Subject: Case No. RO0003098 Technical Response and Data Gap Work Plan

Response to Technical Comments and Data Gap Work Plan

Former Tidewater Service Station 359766
2700 23rd Avenue
Oakland, California
ACEH Case RO0003098

Subject: Fuel Leak Case No. RO0003098 and GeoTracker Global IDT1000004218, Ed's Liquor Store, 2700 23rd Avenue, Oakland, CA 94606-3530

SITE PLAN

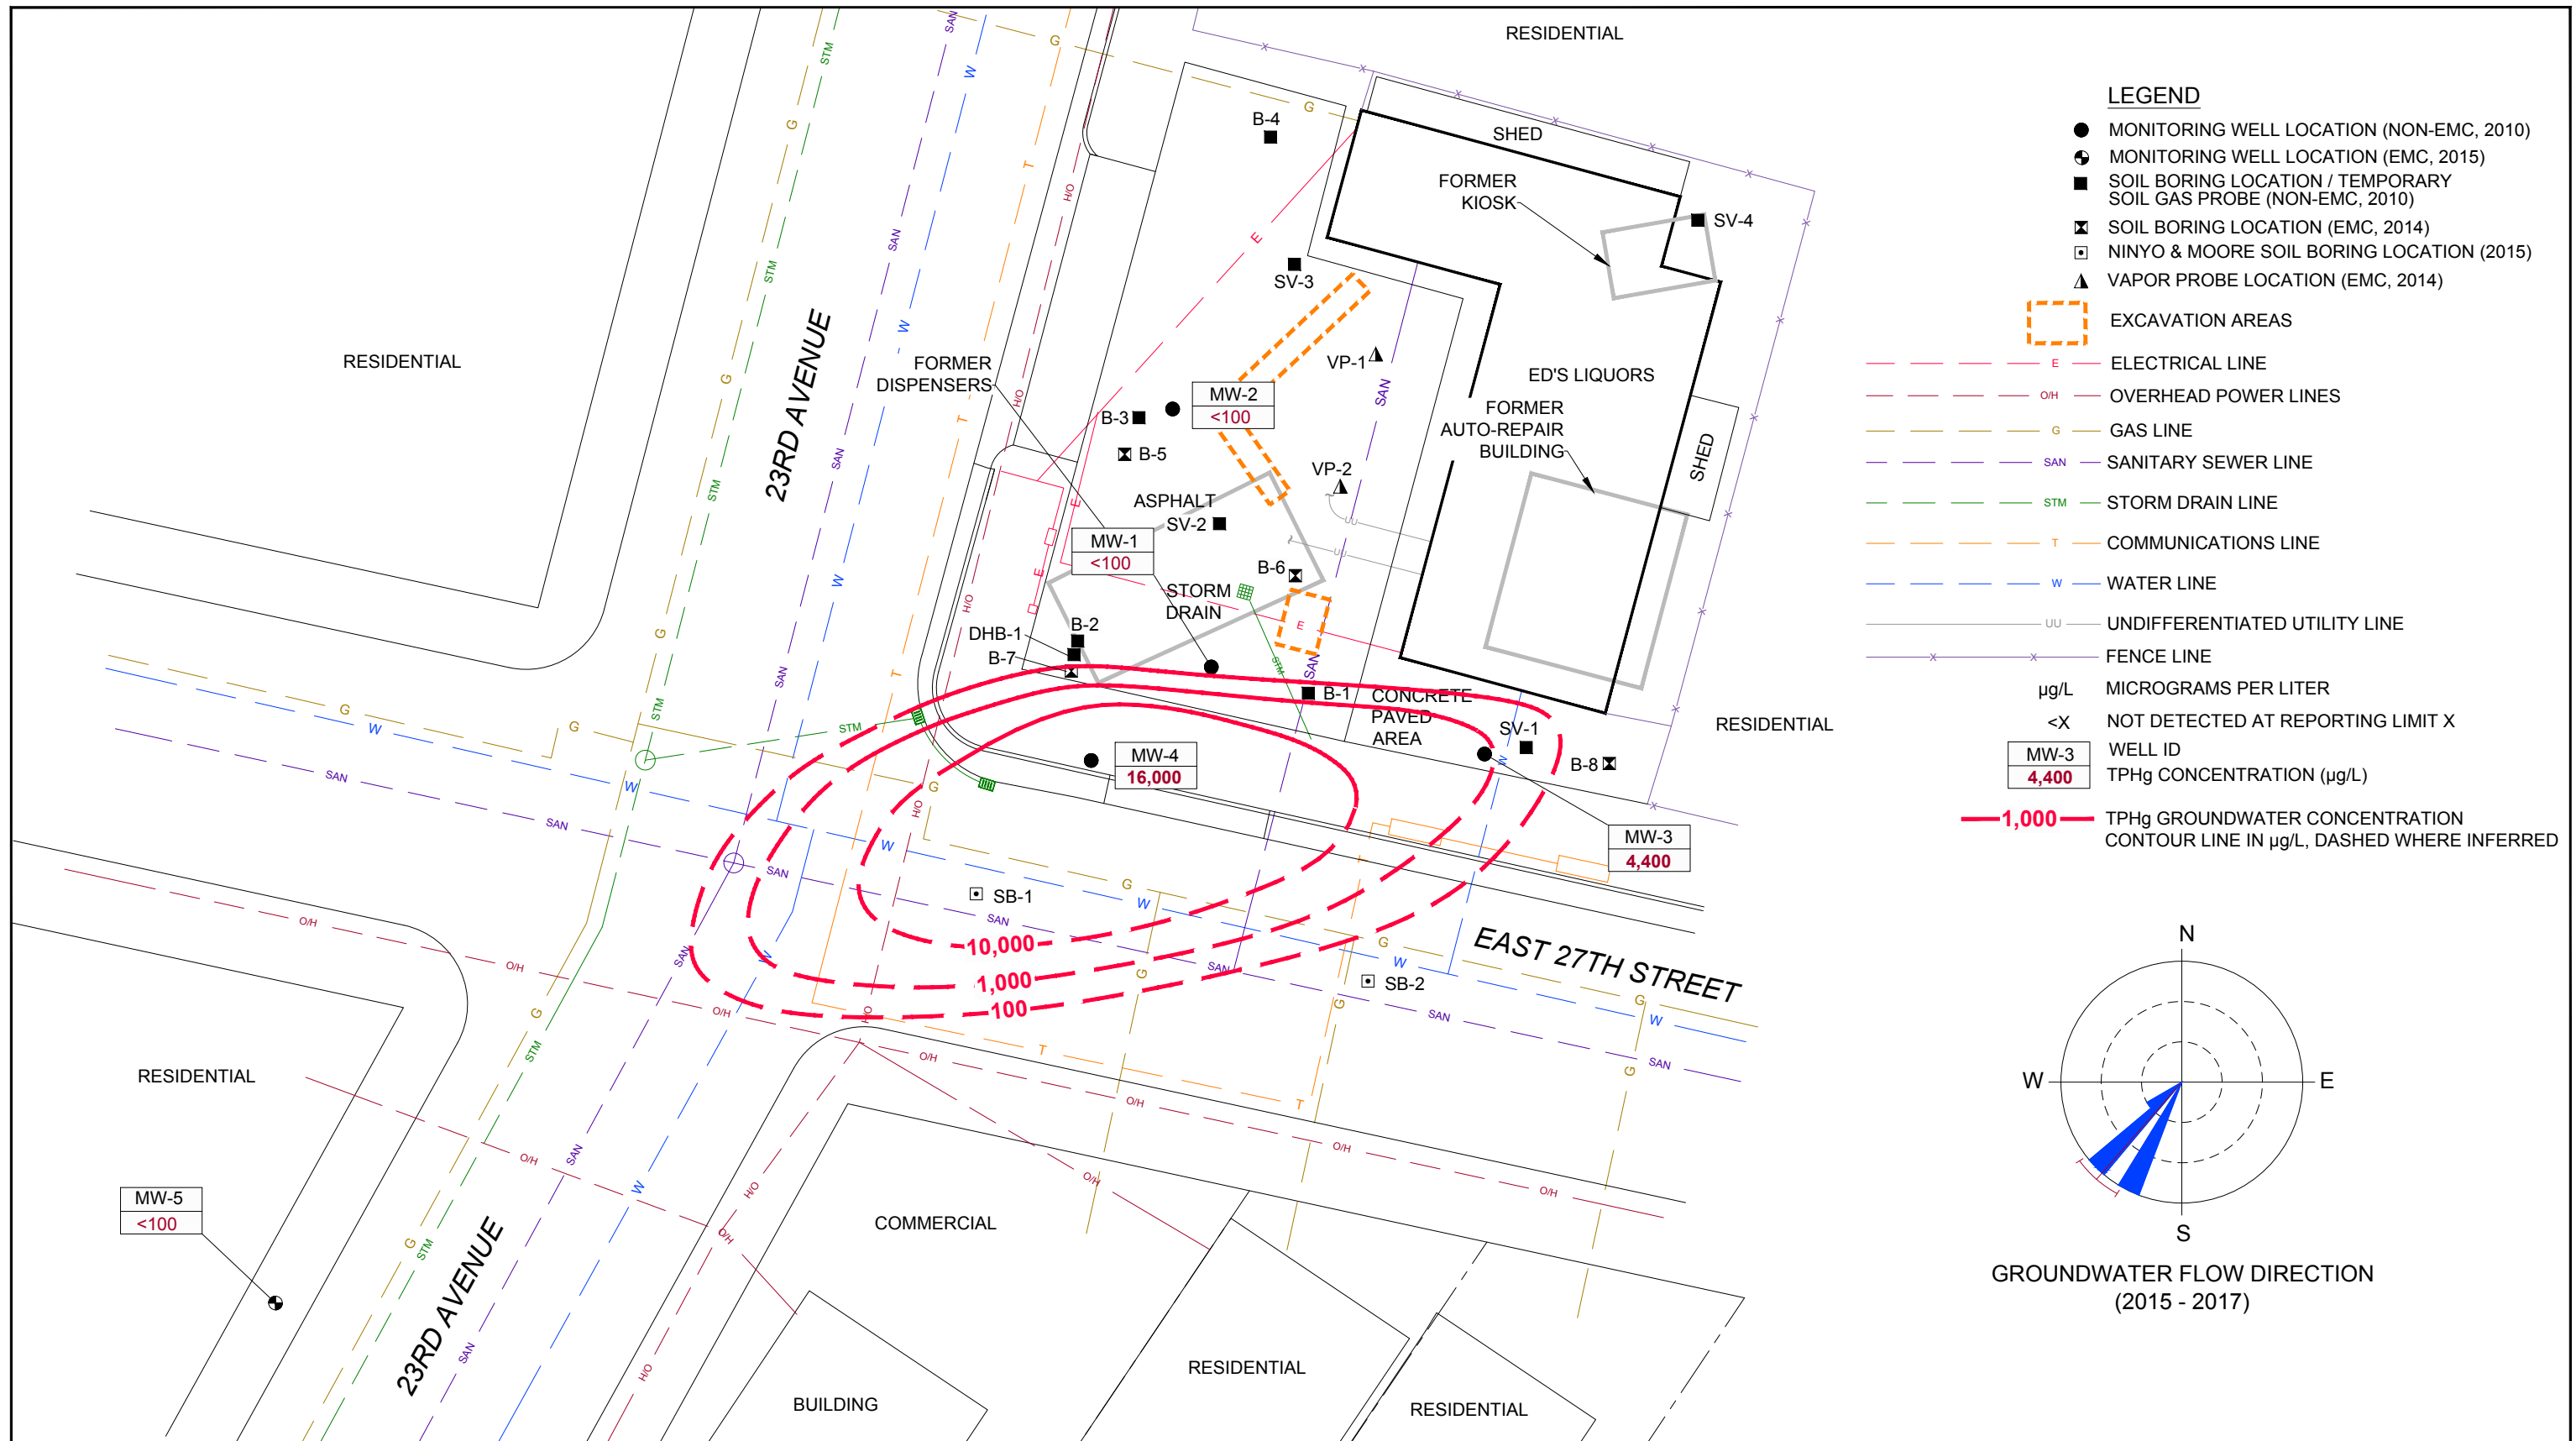
Based on this data it appears the extent of the contaminant plume has not been adequately defined. Contaminant migration in groundwater may pose a vapor intrusion risk to downgradient residents and businesses on E. 27th Street.

Therefore, please present a strategy in the Data Gap Work Plan to evaluate the extent of the contaminant plume including, but not limited to, groundwater monitoring and sampling of all five groundwater monitoring wells for TPHg, TPHd, TPHmo, benzene, toluene, ethylbenzene, and xylenes (BTEX), naphthalene, fuel oxygenates and collection of soil and grab groundwater samples

from borings located upgradient of the residential and commercial businesses on the south side of E-27th Street.

To assess the extent of hydrocarbons south of the site, GHD proposes installing an additional groundwater monitoring well on the south side of East 27th Street (Figure 2).

GHD recommends installing one offsite vapor probe and one offsite groundwater monitoring well (Figure 2). The vapor probe is proposed in the sidewalk and the well is proposed in the parking lot of a restaurant. The well is proposed in the parking lot due to overhead electrical lines above the sidewalk preventing a drill rig safely drilling a well boring at this location.

To assess the extent of dissolved hydrocarbons in groundwater south of the site, GHD will install one monitoring well as shown on Figure 2. The well boring will be advanced using 8-inch outside diameter hollow-stem augers to approximately 20 fbg with an approximate screened interval of 10 to 20 fbg; the screen interval may be modified based on field observation of water levels encountered during drilling activities. The monitoring well will be constructed using 2-inch diameter
